# Technical Service Information

## KM 171-172

### NEW DIPSTICK AND FILLER TUBE (1998 MODELS)

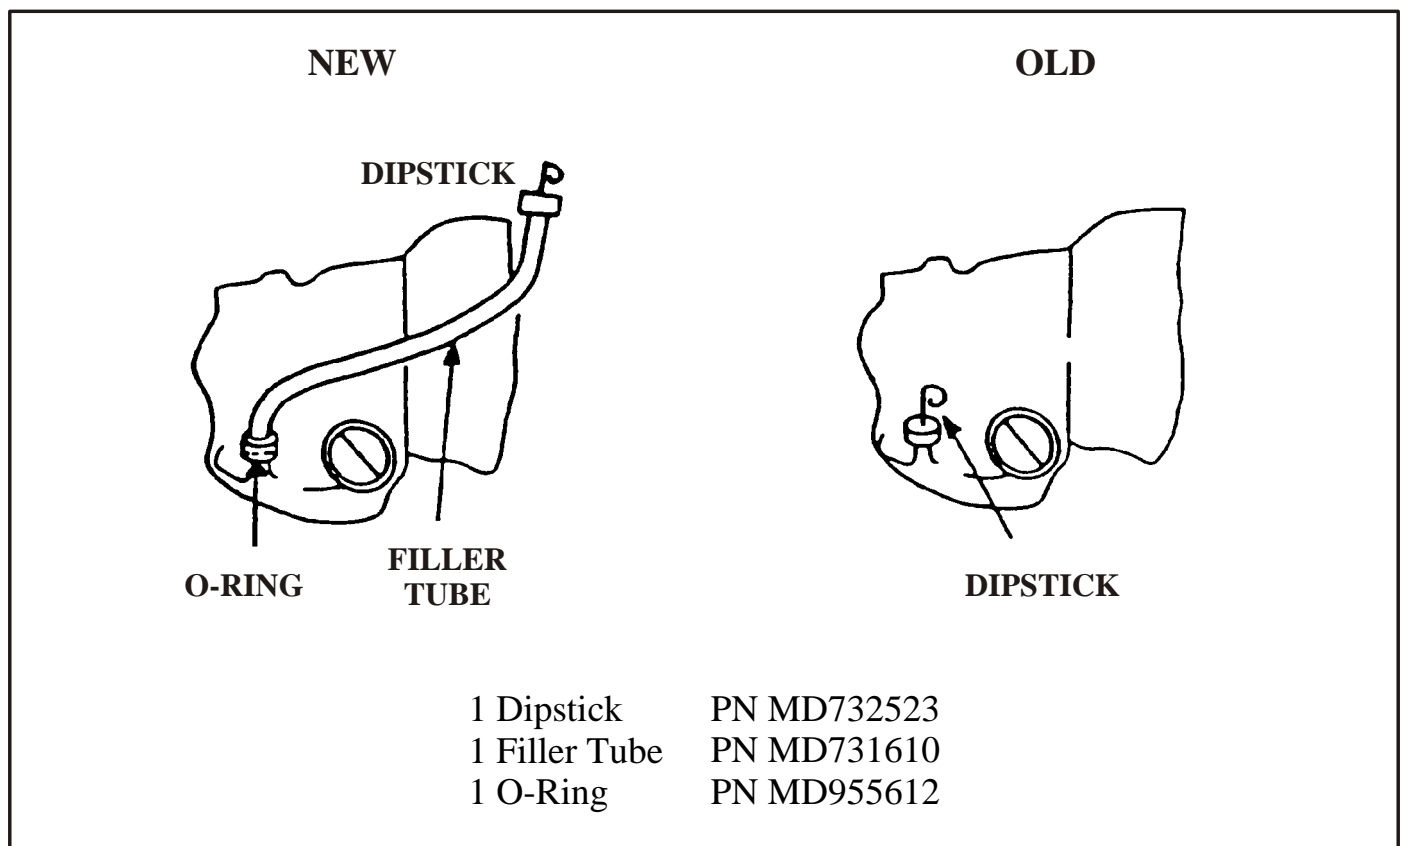
A new dipstick and filler tube has been released, for use on subject model vehicles when equipped with KM171 transaxles. This new dipstick and filler tube are much longer and are positioned for easier access when checking or adding transaxle fluid is necessary (Figure 1). This change was effective in February, 1988, Transaxle No. EF9730 and later.

The new dipstick and filler tube are completely interchangeable with earlier units. However, the dipstick and filler tube must be replaced as a set, along with a new O-ring.
